Newport City Council – Planning Consultation

Application Number: 24/0827

Proposal: OUTLINE APPLICATION FOR A NEW DWELLING

Site: 1 Trinity View Caerleon Newport NP18 3SU

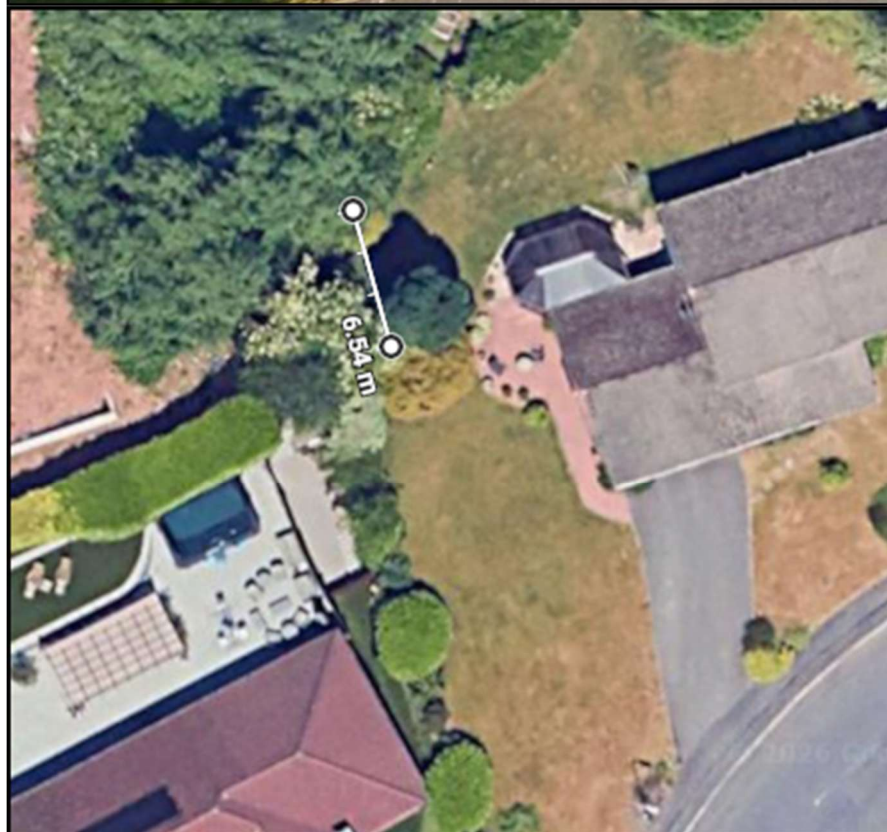
The provided site plan indicates a conifer close to the proposed dwelling, albeit proposed for removal. Using aerial mapping, the canopy of a small group of woody vegetation to the north is approximately 5m from the proposed dwelling and the woodland edge some 10m, and therefore all within potential influencing distance of the proposed dwelling and construction working space etc (refer to Google Imagery screenshots below).

Therefore, a tree survey and tree constraints plan will be required at this Outline Planning Stage. The full application will need to include a combined Arboricultural Implications Assessment and Arboricultural Method Statement. If the full application is >12 months later than the tree survey date, then this will need to be updated at the application stage.
